PROPOSAL FOR DRAFT AMENDMENTS TO THE GTR ON PEDESTRIAN PROTECTION
(gtr No. 9)

(Document ECE/TRANS/180/Add.9)

A. STATEMENT OF TECHNICAL RATIONALE AND JUSTIFICATION

B. TEXT OF REGULATION

Figure 13: Flex-PLI; Dimensions and C.G. locations of femur, knee joint, and tibia (Side view)

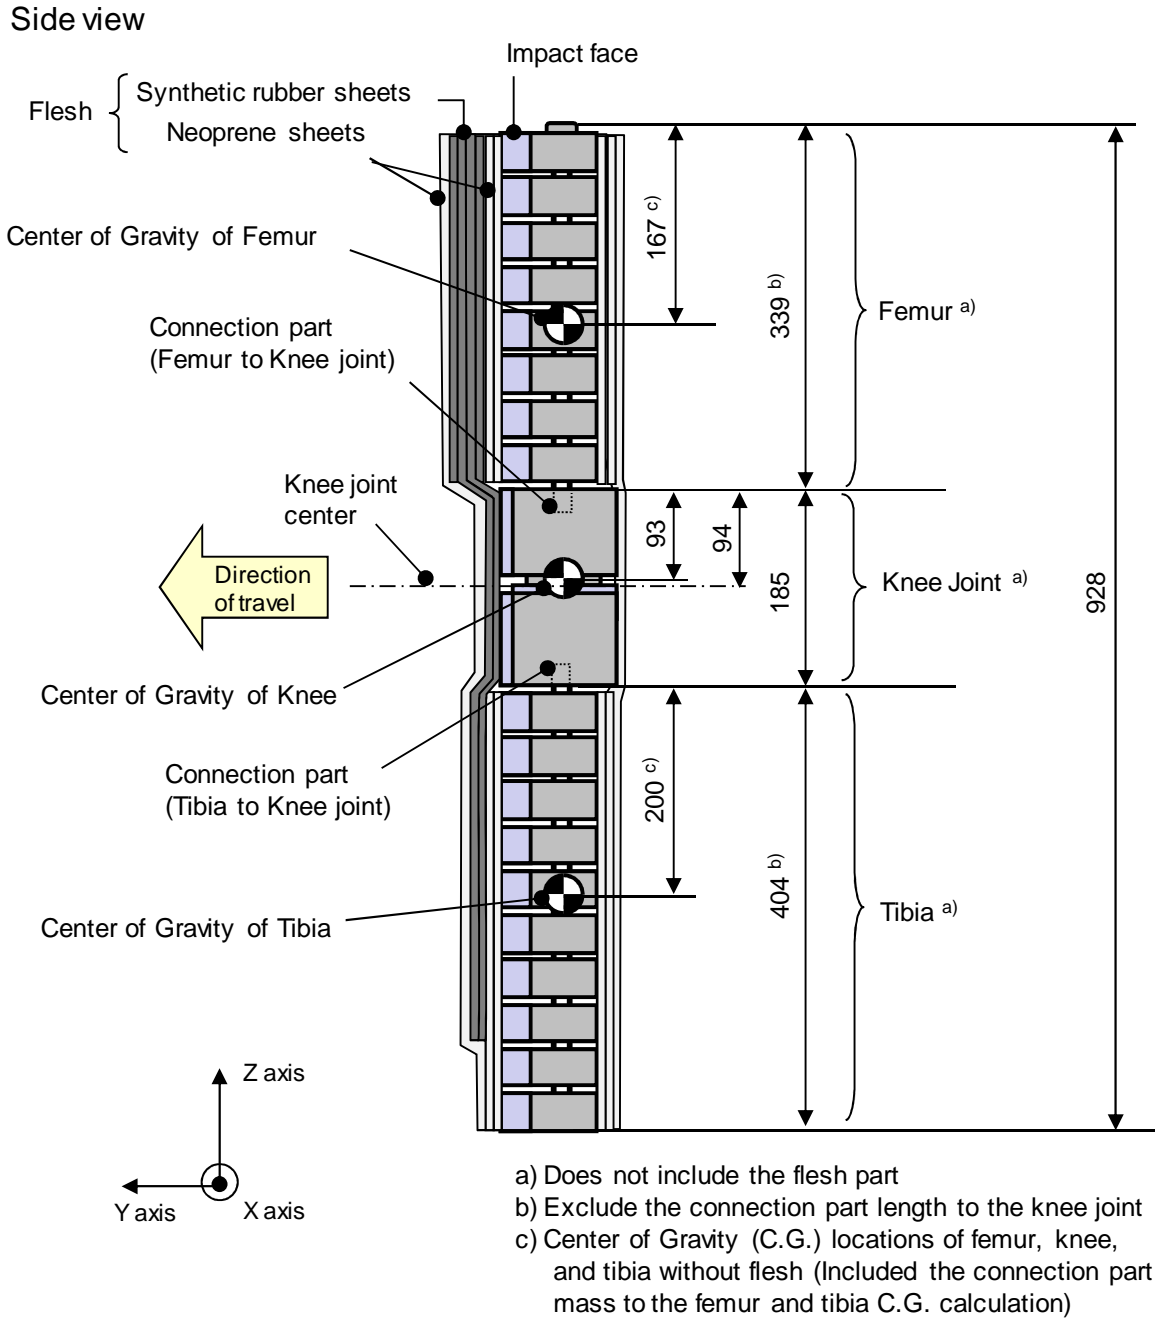
The lower legform impactor shall consist of flesh, flexible long bone segments (representing femur and tibia), and a knee joint as shown in Figure 13.

The overall length of the impactor shall be $928 \pm [3]$ mm, having a required mass of $12.95 \pm [0.4]$ kg including flesh. The length of the femur, knee joint, and tibia shall be $339 \pm [2]$ mm, $185 \pm [1]$ mm, and $404 \pm [2]$ mm respectively. The knee joint centre position shall be $94 \pm [1]$ mm from the top of the knee joint.

The centre of gravity of the femur and tibia without flesh, including the connection part to the knee joint, shall be $167 \pm [3]$ mm and $200 \pm [3]$ mm respectively from the top, but not including the connection part to the knee joint, of each part as shown in Figure 13. The centre of gravity of the knee shall be $93 \pm [3]$ mm from the top of the knee joint as shown in Figure 13.

Figure 14: Flex-PLI; femur, tibia, and knee dimensions (Top view)

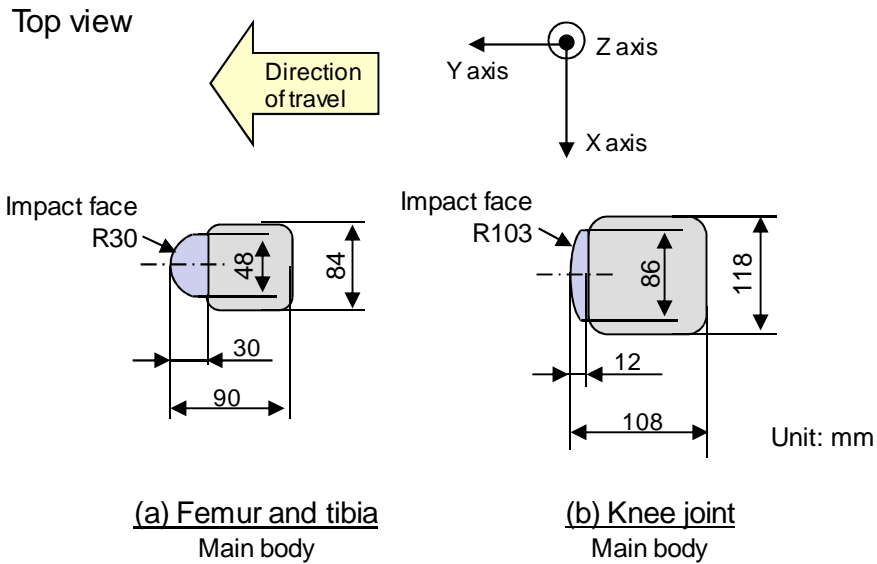
6.3.1.2.1. **The cross-sectional shape perpendicular to the Z axis of the femur and tibia main bodies shall be $90 \pm [2]$ mm in width along the Y axis, and $84 \pm [1]$ mm in width**

along the X axis as shown in Figure 14 (a). The impact face shall be $30 \pm [1]$ mm in radius, $30 \pm [1]$ mm in width along the Y axis, and $48 \pm [1]$ mm in width along the X axis as shown in Figure 14 (a).

6.3.1.2.2. The cross-sectional shape perpendicular to the Z axis of the knee joint shall be $108 \pm [2]$ mm in width along the Y axis, and $118 \pm [1]$ mm in width along the X axis as shown in Figure 14 (b). The impact face shall be $103 \pm [1]$ mm in radius, $12 \pm [1]$ mm in width along the Y axis, and $86 \pm [1]$ mm in width along the X axis as shown in Figure 14 (b).

Figure 15: Flex-PLI; flesh dimensions and mass

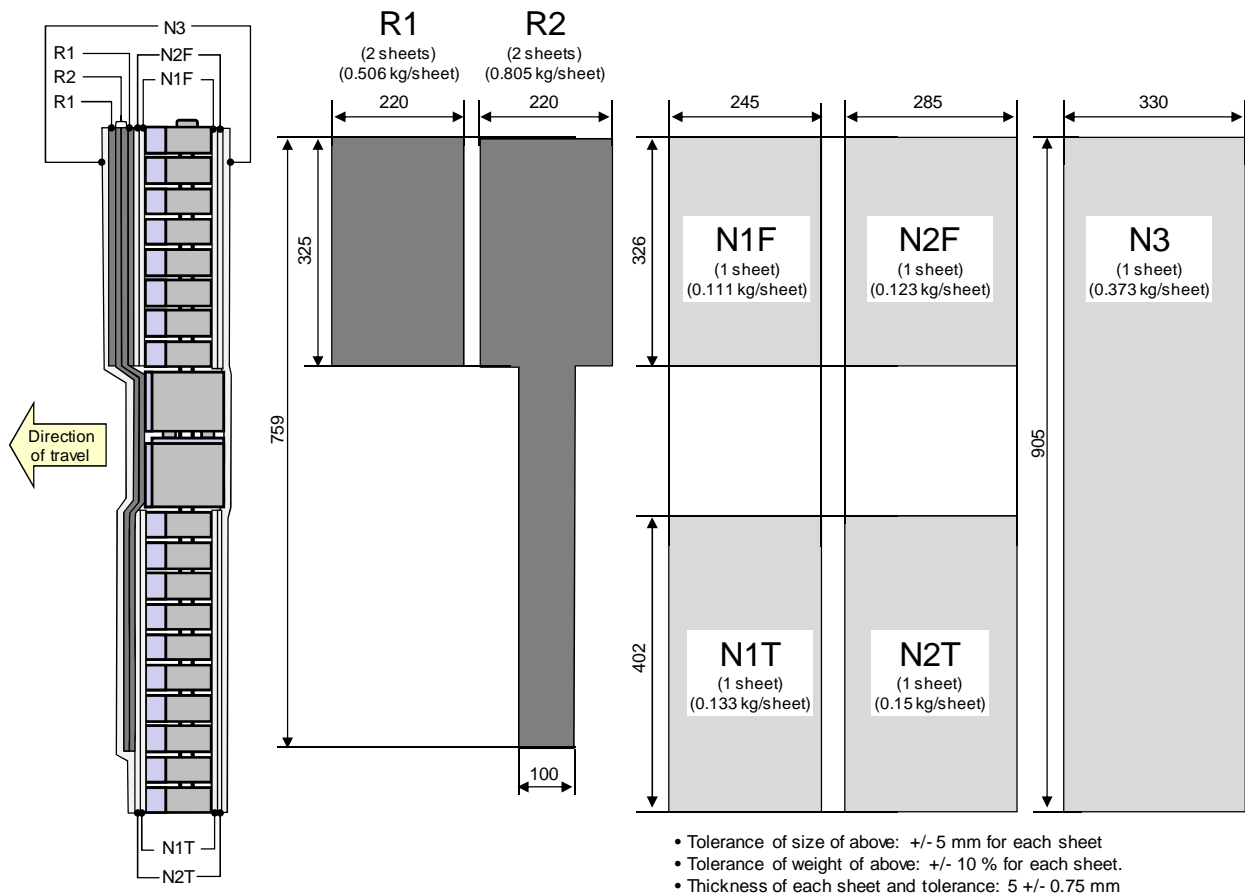
6.3.1.2.4. For each test, the impactor (femur, knee joint, and tibia) shall be covered by flesh composed of synthetic rubber sheets (R1, R2) and neoprene sheets (N1F, N2F, N1T, N2T, N3) as shown in Figure 15. The sheets are required to have a compression characteristic as shown in Figure 16. The compression characteristic shall be checked using the same batch of sheets as those used for the impactor flesh. The size and weight of the sheets shall be within the requirements described in Figure 16.

Figure 17: Flex-PLI; instrument locations "

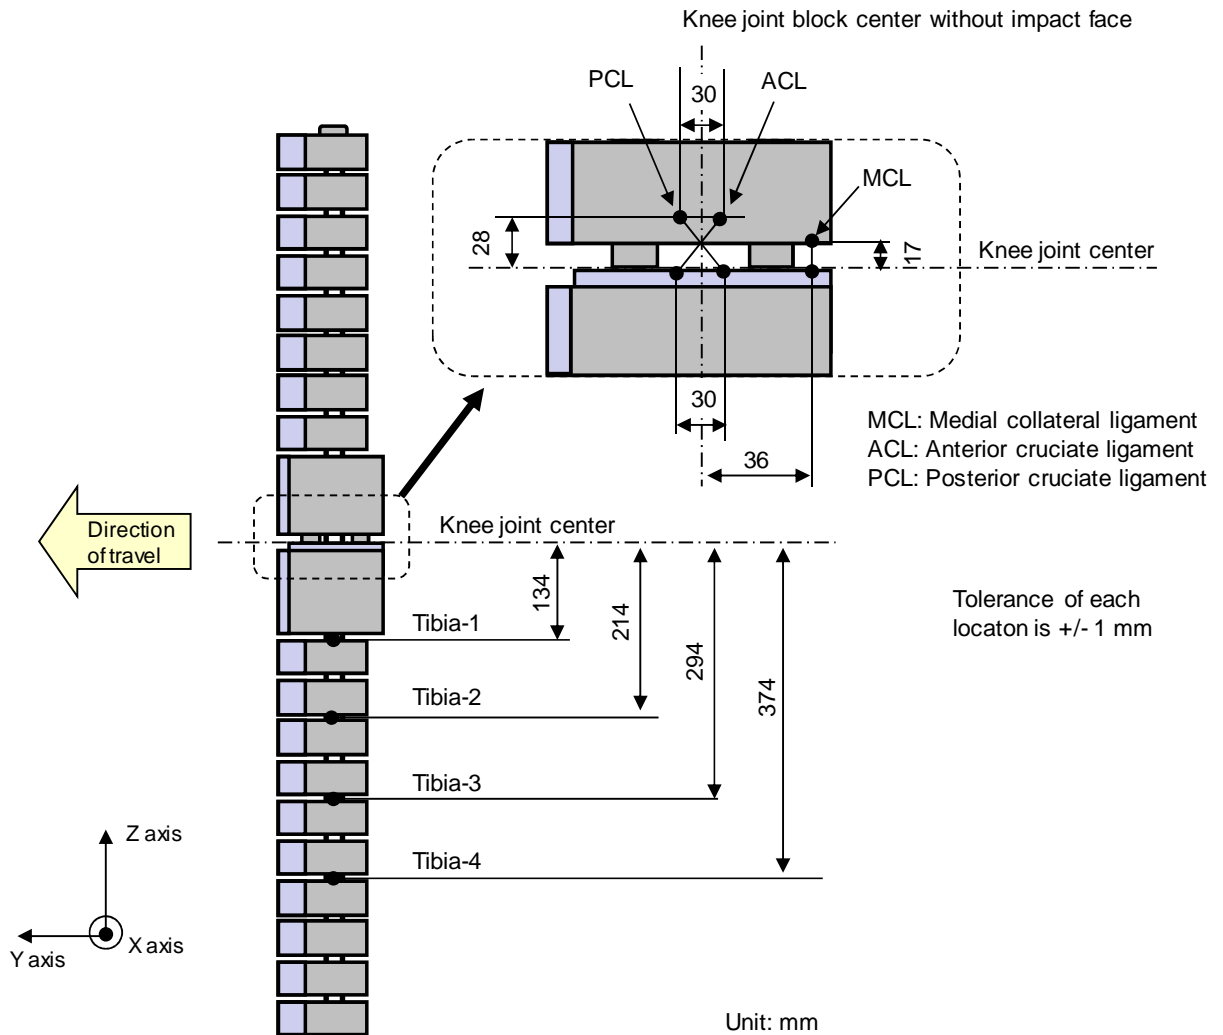
- 6.3.1.2.6.1.** Four transducers shall be installed in the tibia to measure bending moments applied to the tibia. The sensing locations of each of the transducers are as follows: tibia-1: $134 \pm [1]$ mm, tibia-2: $214 \pm [1]$ mm, tibia-3: $294 \pm [1]$ mm, and tibia-4: $374 \pm [1]$ mm below the knee joint centre respectively as shown in Figure 17. The measurement axis of each transducer shall be the X axis of the impactor.

- 6.3.1.2.6.2.** Three transducers shall be installed in the knee joint to measure elongations of the medial collateral ligament (MCL), anterior cruciate ligament (ACL), and posterior cruciate ligament (PCL). The measurement locations of each transducer are shown in Figure 17. The measurement locations shall be within $\pm [3]$ mm along the X axis from the knee joint centre.

Figure 23: Tolerances of angles for the lower legform impactor at the time of the first impact (see paragraphs 7.1.2.2. and 7.1.2.3.2.)

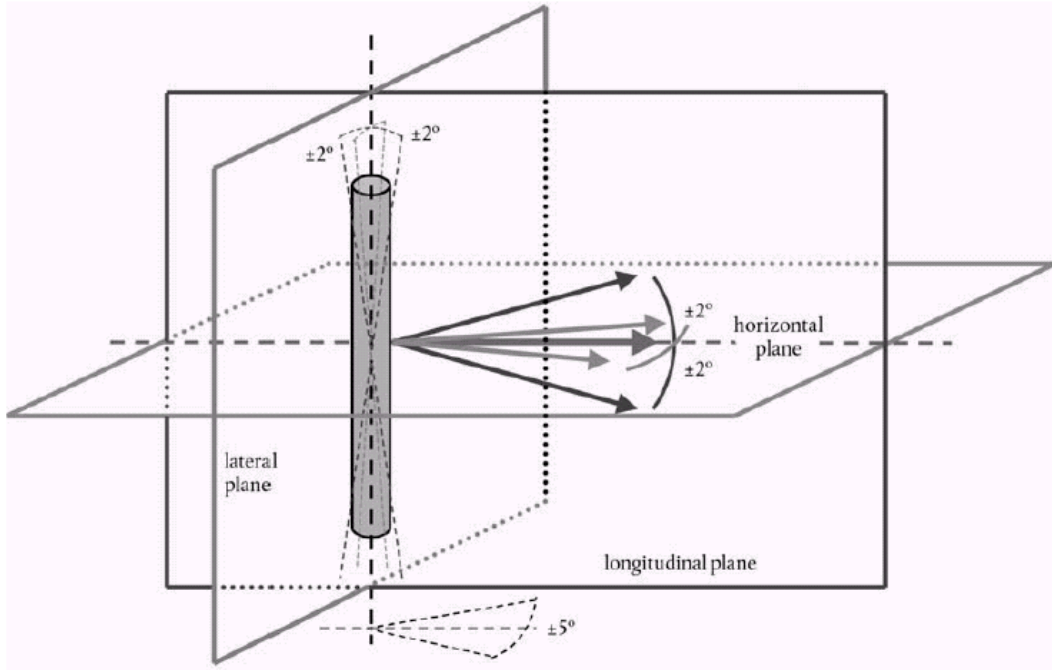
7.1.2.2. The direction of the impact velocity vector shall be in the horizontal plane and parallel to the longitudinal vertical plane of the vehicle. The tolerance for the direction of the velocity vector in the horizontal plane and in the longitudinal plane shall be $\pm 2^\circ$ at the time of first contact. The axis of the impactor shall be perpendicular to the horizontal plane with a tolerance of $\pm 2^\circ$ in the lateral and longitudinal plane. The horizontal, longitudinal and lateral planes are orthogonal to each other (see Figure 23).

7.1.2.3.2. At the time of first contact the impactor shall have the intended orientation about its vertical axis, for the correct operation of its knee joint, with a tolerance of $\pm 5^\circ$ (see Figure 23).

Figure 24: Flex-PLI to bumper tests for complete vehicle in normal ride attitude (left) and for cut-body mounted on supports (right) (see paragraph 7.1.2.3.) "

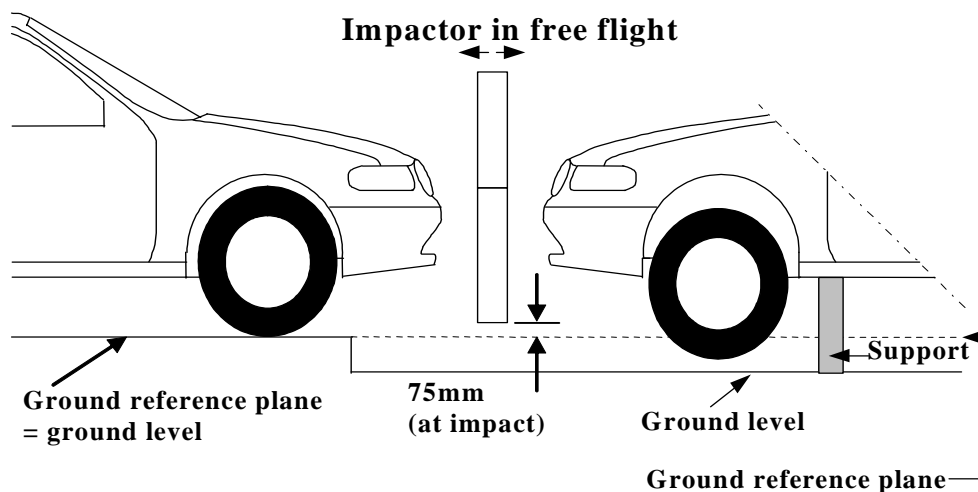
7.1.2.3. The bottom of the impactor shall be at 75 mm above ground reference plane at the time of first contact with the bumper (see Figure 24), with a ± 10 mm tolerance. When setting the height of the propulsion system, an allowance must be made for the influence of gravity during the period of free flight of the impactor.

Figure 31: Requirement corridor of femur and tibia in static certification test (see paragraph 8.2.1.2.)

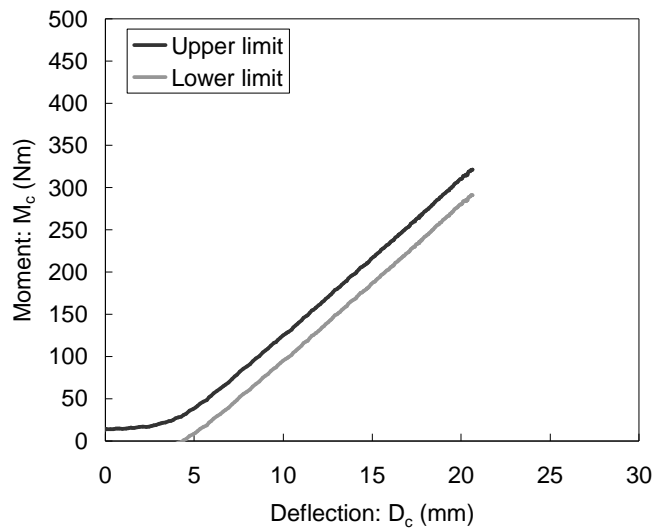
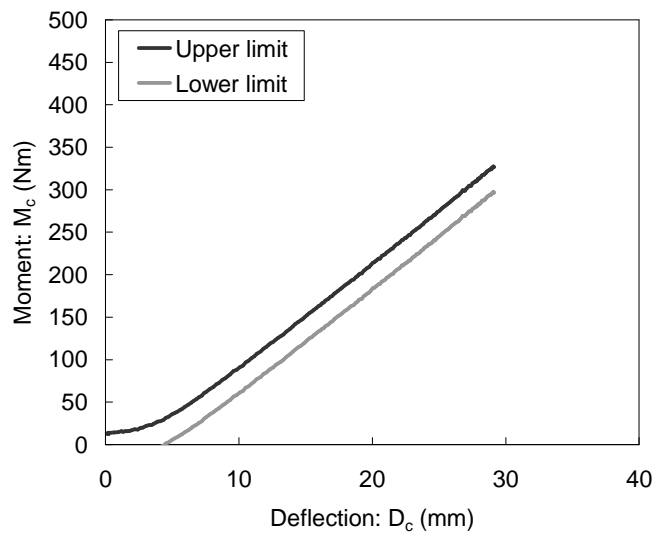
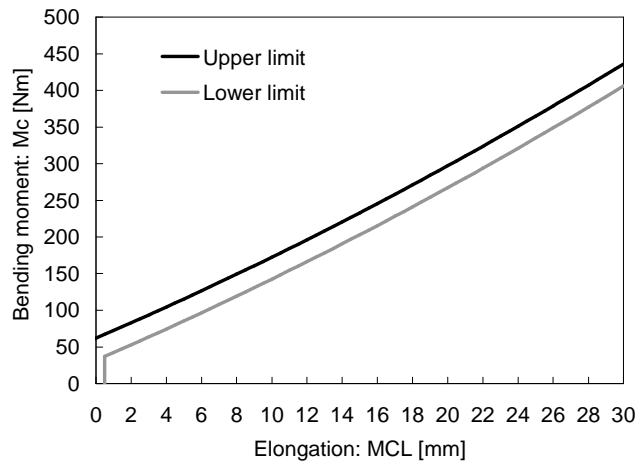
8.2.1.2. When the femur and tibia of the impactor are loaded in bending in accordance with paragraph 8.2.1.4., the applied moment and generated deflection at the centre of the femur and tibia (M_c and D_c) shall be within the corridors shown in Figure 31.

Figure 32: Requirement corridors for knee joint in static certification test (see paragraph 8.2.1.3.)

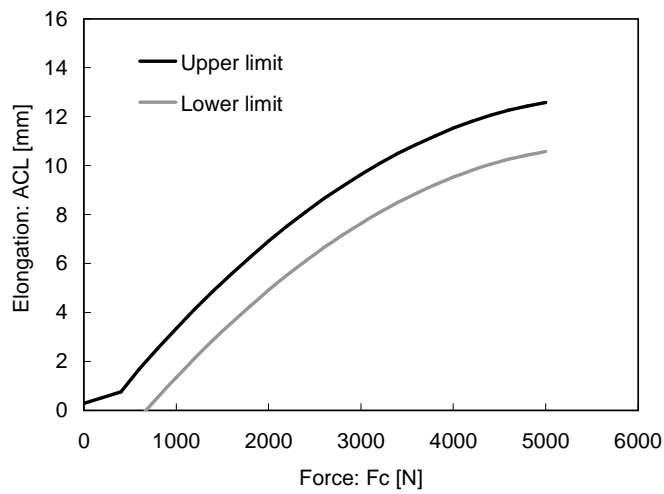
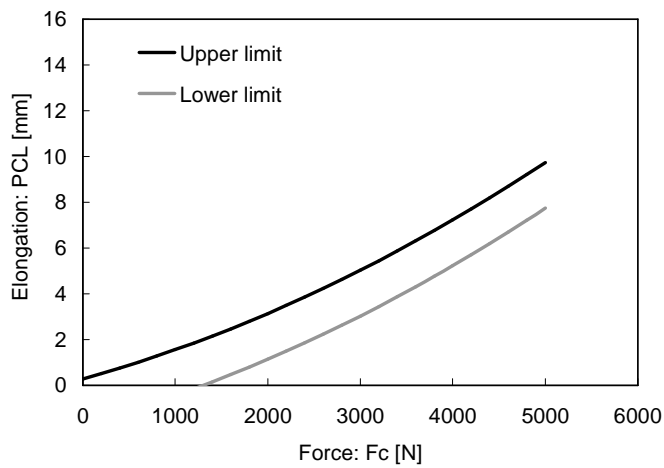
8.2.1.3. When the knee joint of the impactor is loaded in bending in accordance with paragraph 8.2.1.5., the MCL, ACL, and PCL elongations and applied bending moment or force at the centre of the knee joint (M_c or F_c) shall be within the corridors shown in Figure 32.

Figure 33: Test set-up for femur in static certification tests
(see paragraph 8.2.1.4.)

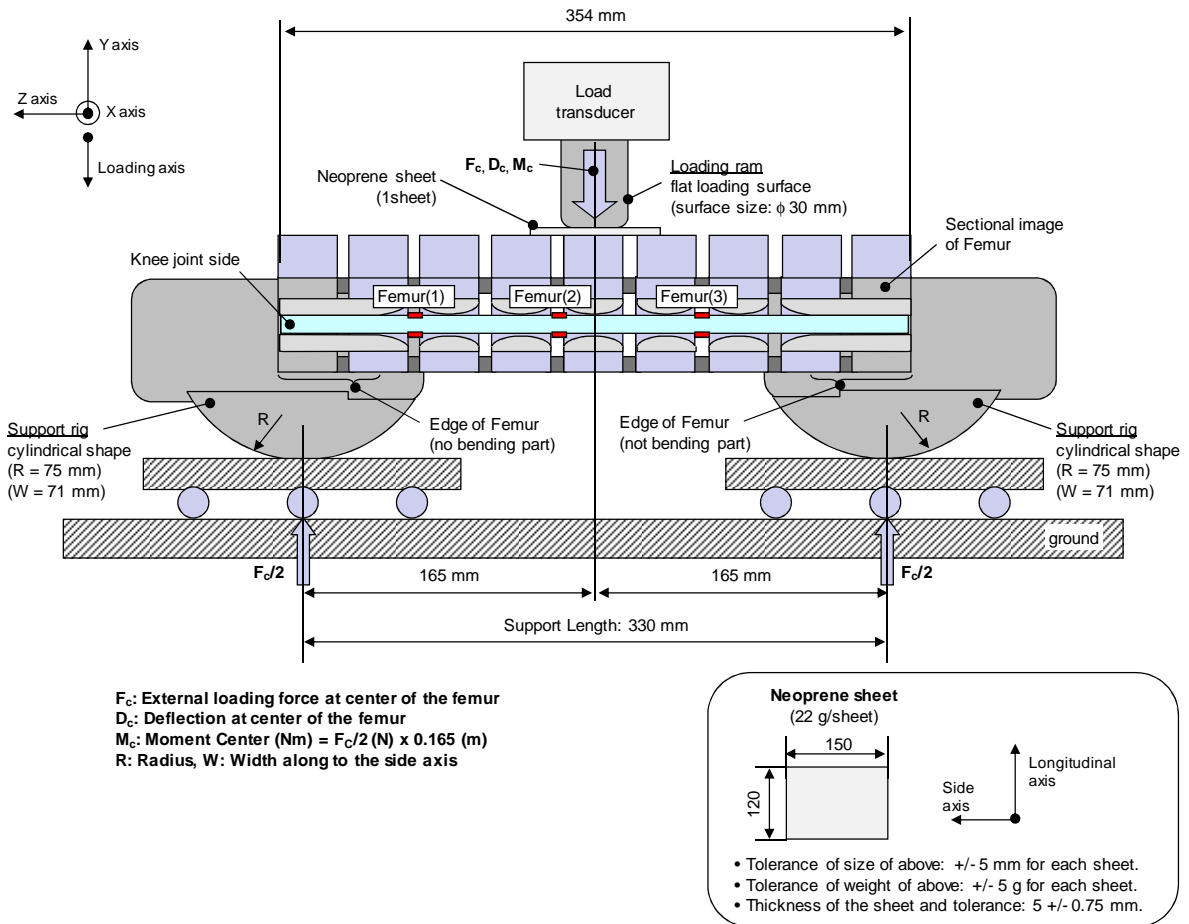
8.2.1.4. The edges, of the femur and tibia, not bending parts, shall be mounted to the support rig firmly as shown in Figure 33. The Y axis of the impactor shall be parallel to the loading axis within $180 \pm 2^{\circ}$ tolerance. In order to avoid friction errors, roller plates shall be set underneath the support rigs. To avoid impactor damage, a neoprene sheet shall be set underneath the loading ram. The neoprene sheet used in this test shall have compression characteristics as shown in Figure 16.

The centre of the loading force shall be applied at the centre of the femur and tibia within $\pm [2^{\circ}]$ tolerance along the Z axis. The force shall be increased at a rate between 10 and 100 mm/minute until the bending moment at the centre part (M_c) of the femur or tibia reaches 312 Nm.
